Scope Revision Narrative

Austin Police Association Office Building Renovation

Addendum No.: 3

Date: 2026-07-22

E1.1

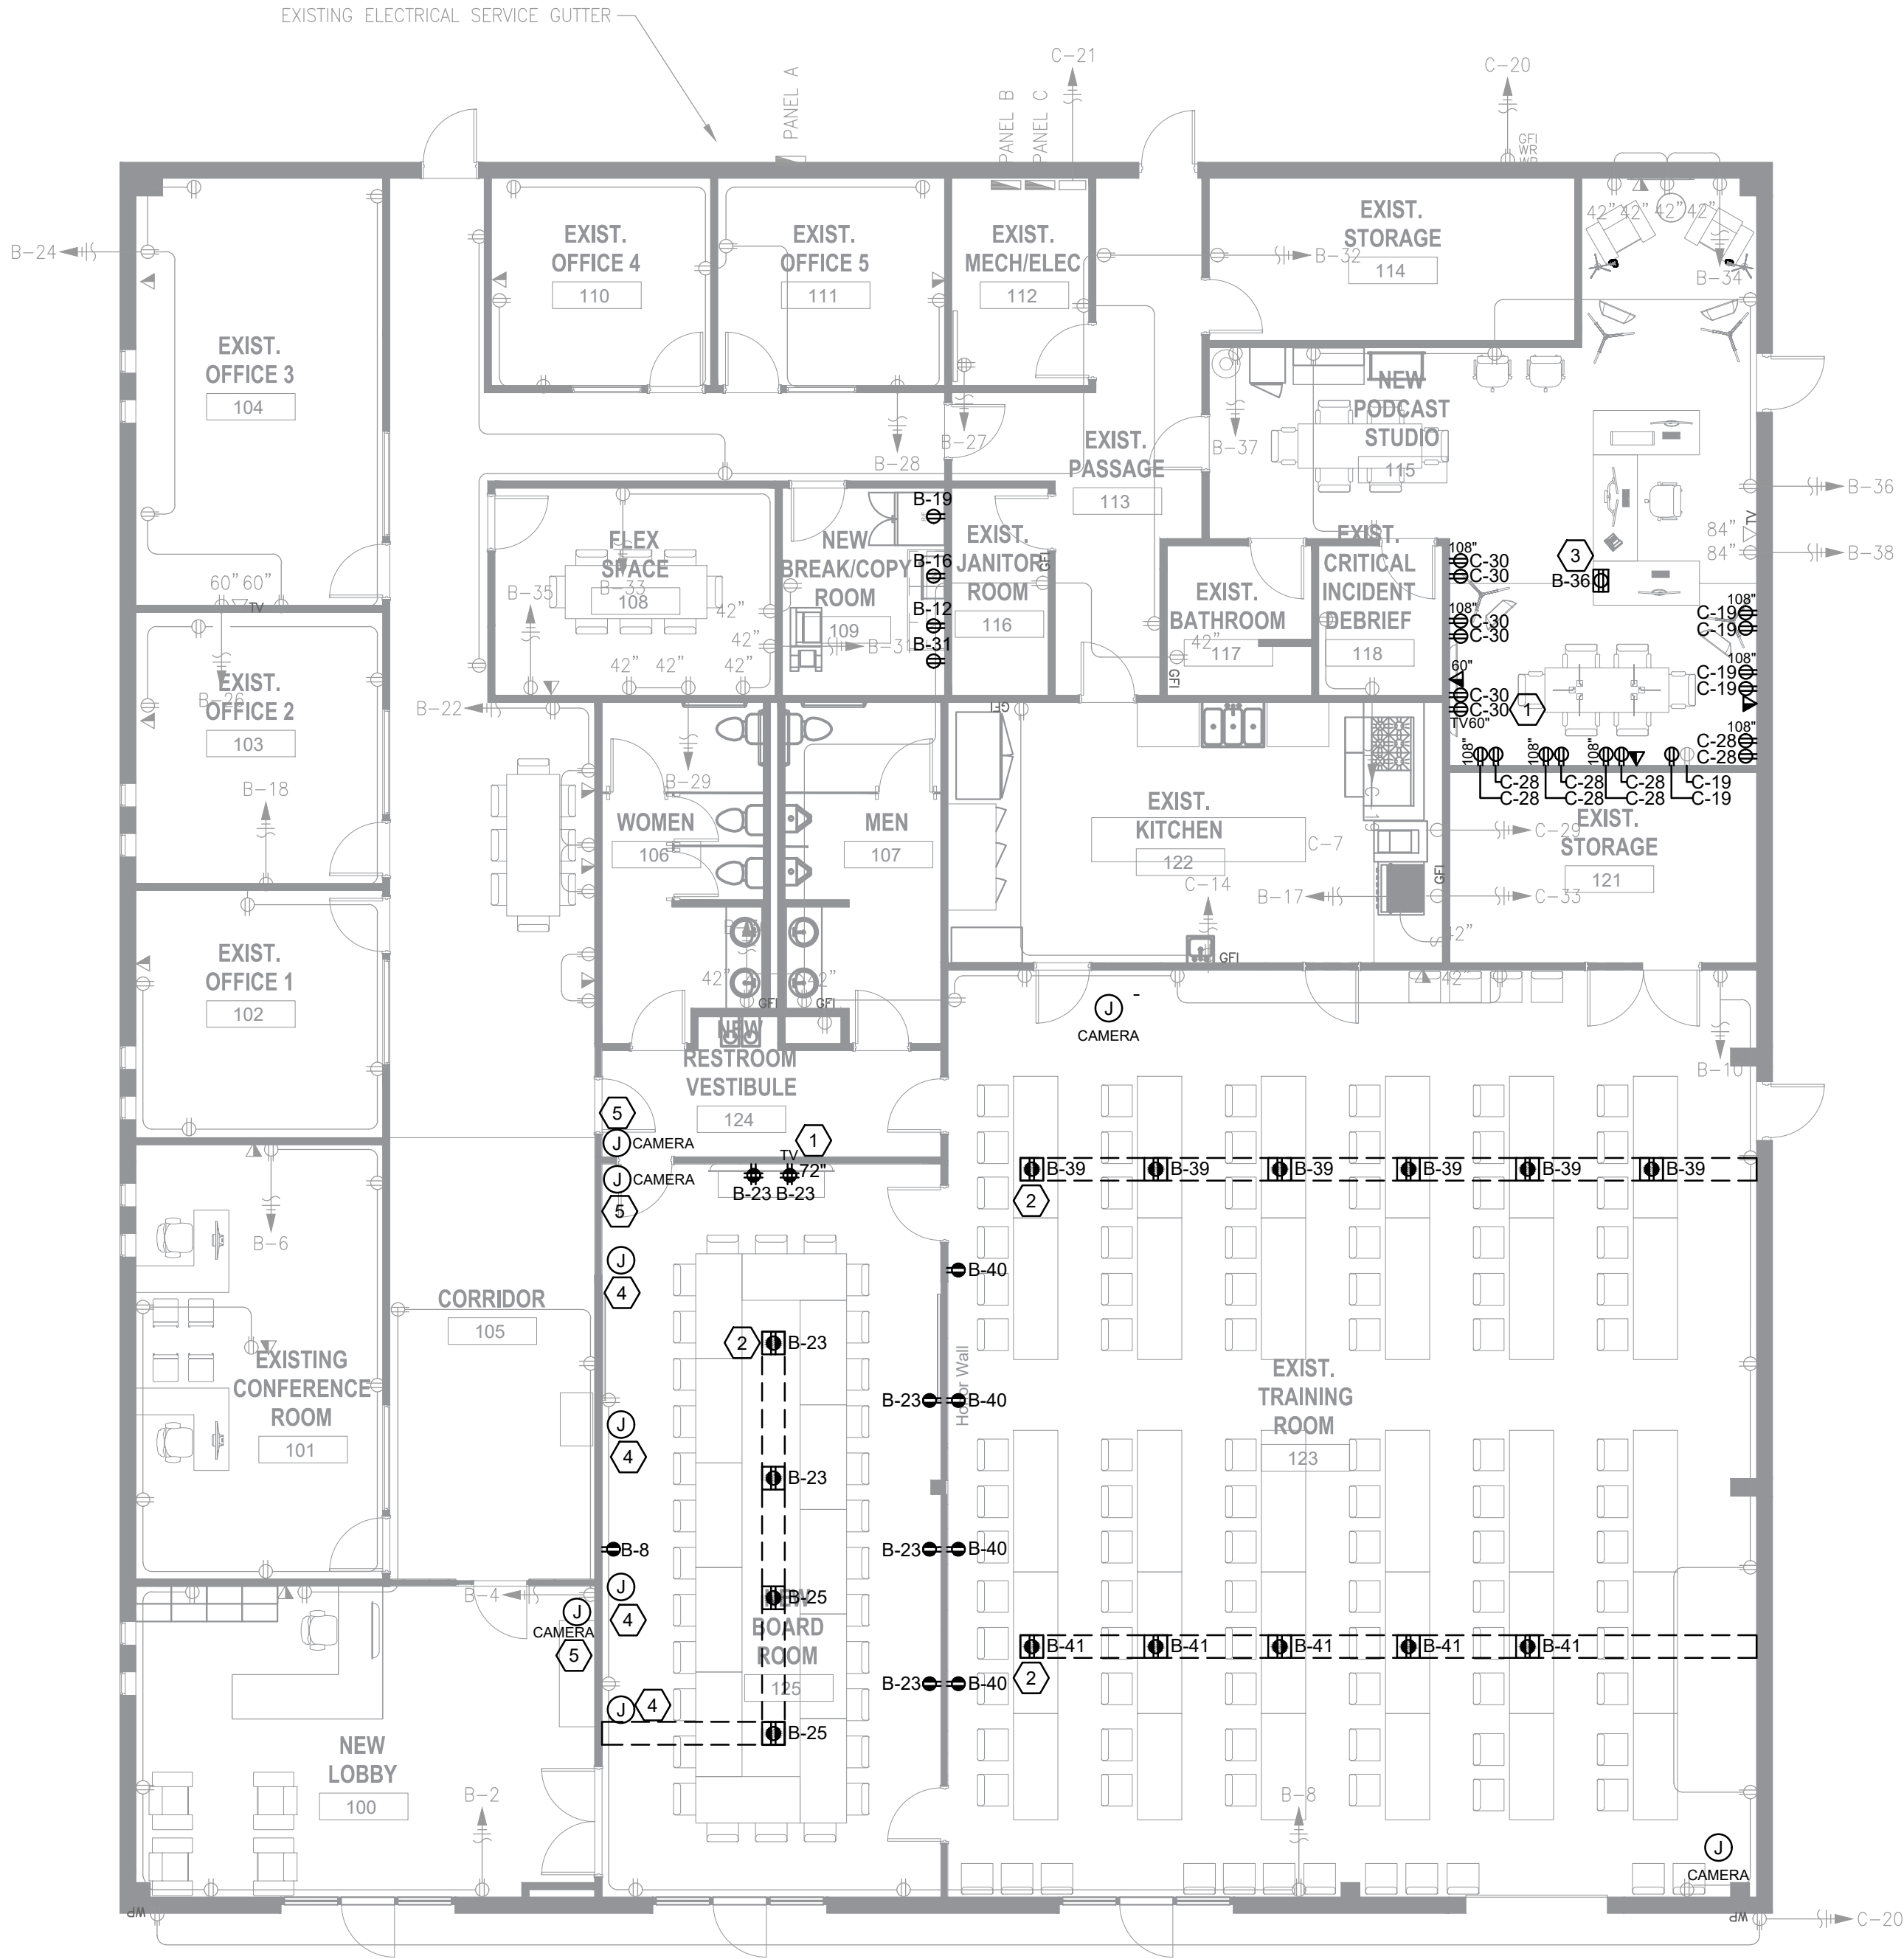
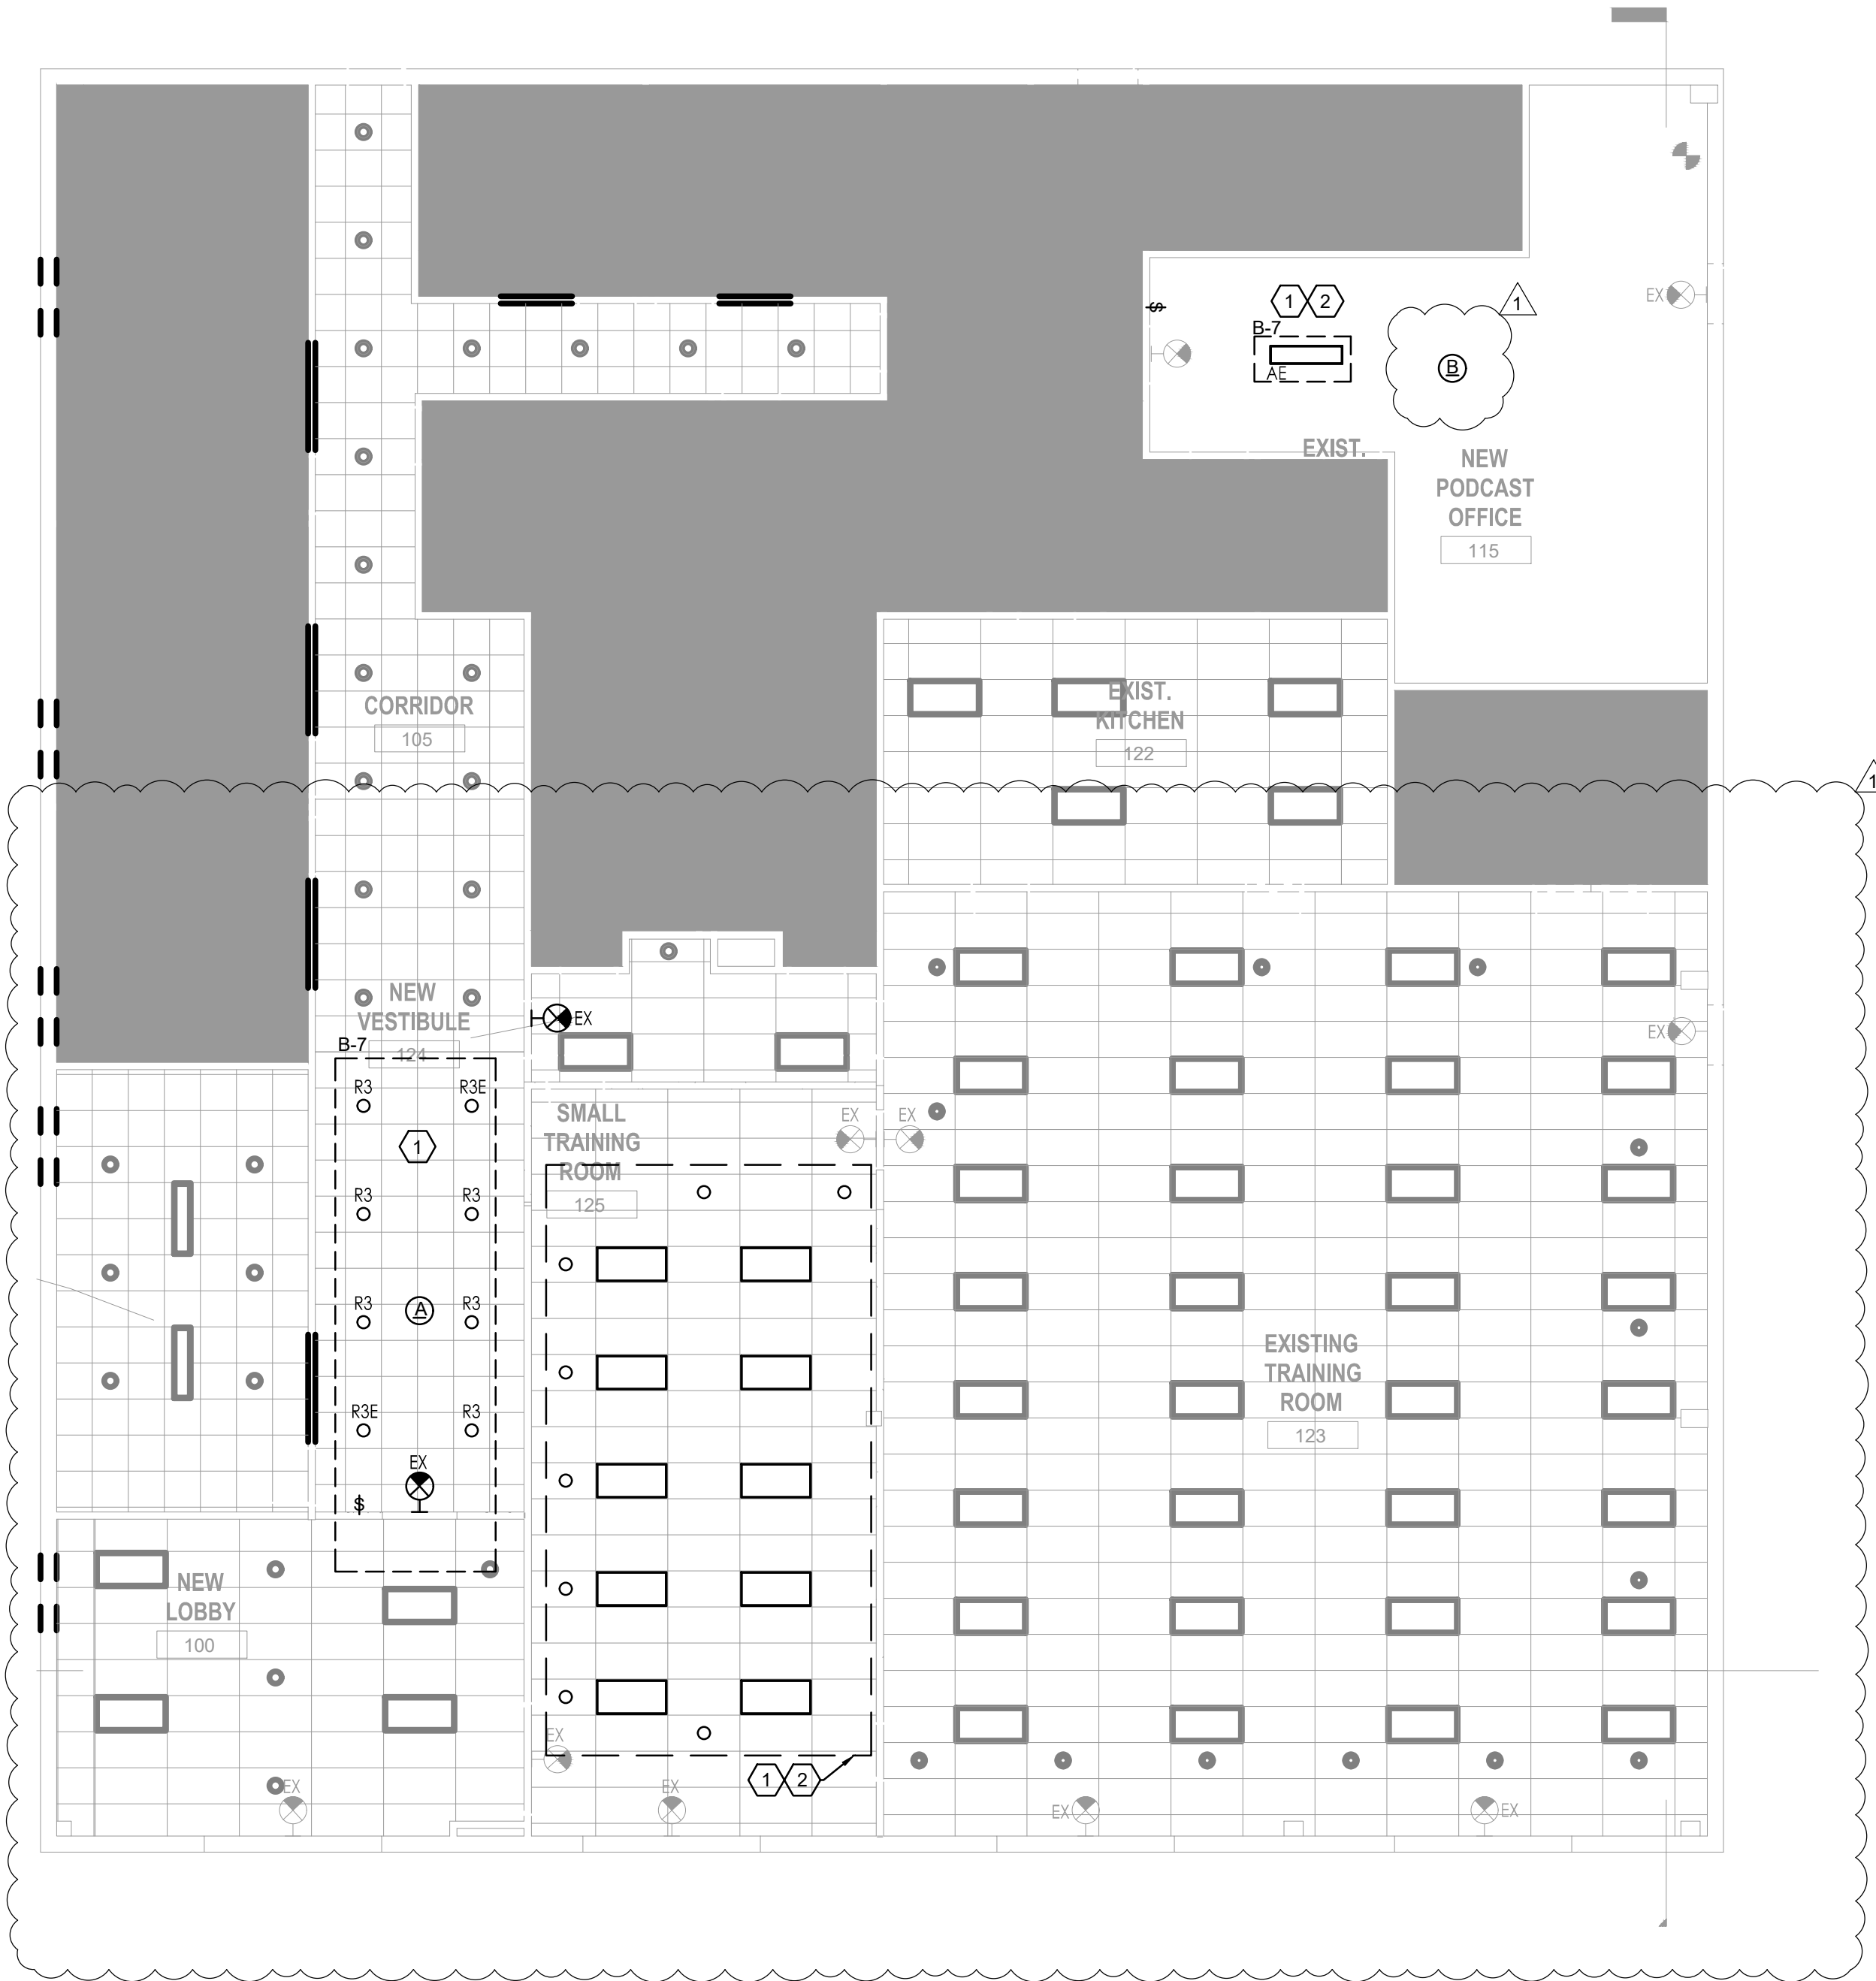
1. CONNECT LIGHT FIXTURE TO THE EXISTING CIRCUIT IN THIS ROOM. CONFIRM CIRCUIT NOTED SERVES ROOM; ALTERNATELY RECONNECT TO EXISTING CIRCUIT IN ROOM.
2. REINSTALL EXISTING LIGHT FIXTURES ON NEW CEILING GRID.

2. For new light fixtures remaining within the project scope, provide standalone occupancy or vacancy sensors and local lighting controls where required by the applicable energy code.
3. A centralized or networked lighting-control system is not required.
